An example part that is sometimes used to explain applications of Profile of a Surface:

Assertion:

Problem for Industry:

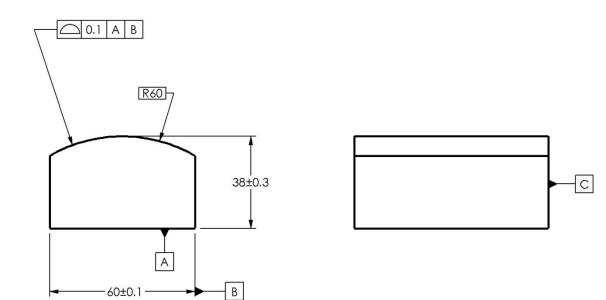
> The combination of ± and profile (with no vertical basic) is said to make the profile call-out control only form and orientation:

Supported by Figure 8-27 & section 8.8, but only for Profile of a Line?

Is the profile tolerance zone now also free to translate horizontally, since there is no horizontal basic dimension shown?

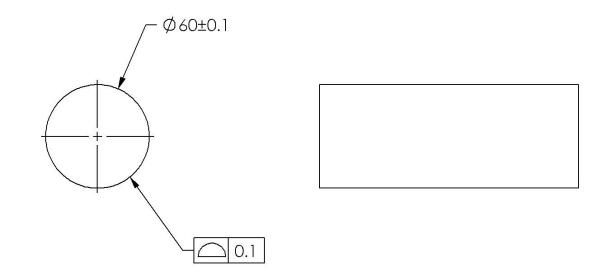
Since no basic diameter dimension is included, does the profile tolerance impose a tolerance zone that is the same as cylindricity?

Now with a pin that has an elliptical cross-section, how does this work?

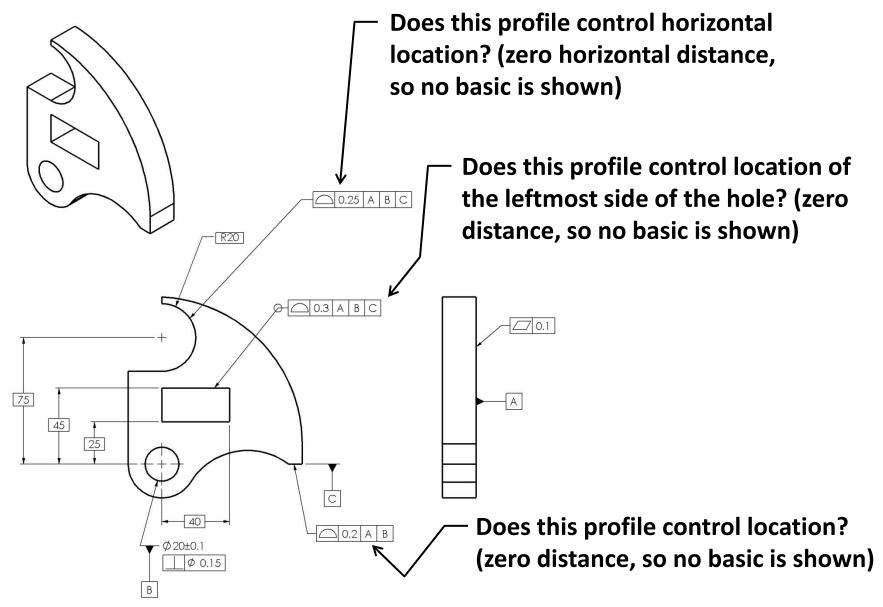
Since basic dimensions must be provided to define the shape of the profile tolerance zone, how can this profile tolerance control only form?

What if a drawing is completed per Y14.41, with only annotation of the 3D CAD model? There are likely no basic dimensions shown, just a note stating "BASIC DIMENSIONS FROM 3D CAD MODEL".

How could the presence or absence of a basic dimension affect what a profile tolerance controls when no basics are shown?

Since basic dimensions for distances of zero, or angles of zero or any increment of 90°, do not need to be shown, and especially since specifications per Y14.41 will show no basic dimensions, the presence or absence of basic dimensions should not affect which geometric characteristics (form, size, orientation, or location) are controlled by profile tolerances.

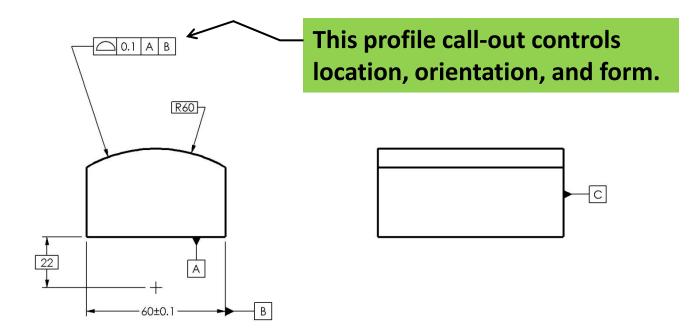
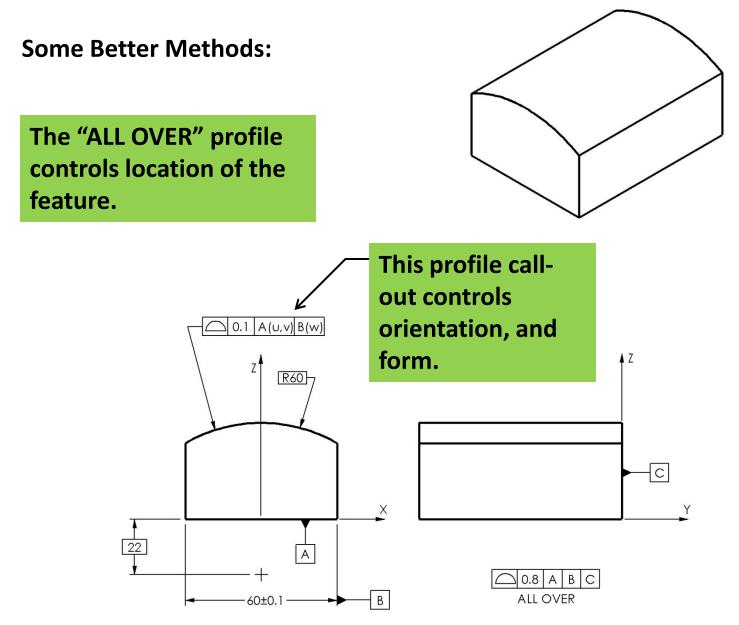
Many people view Y14.5 as specifying that the presence or absence of basic dimensions does affect the control provided by a profile tolerance. This is largely due to the inclusion of figures that combine profile and \pm tolerances.

This ambiguity creates confusion and therefore expense for industry.

If the 22 mm basic dimension were left off then the drawing would be incomplete.
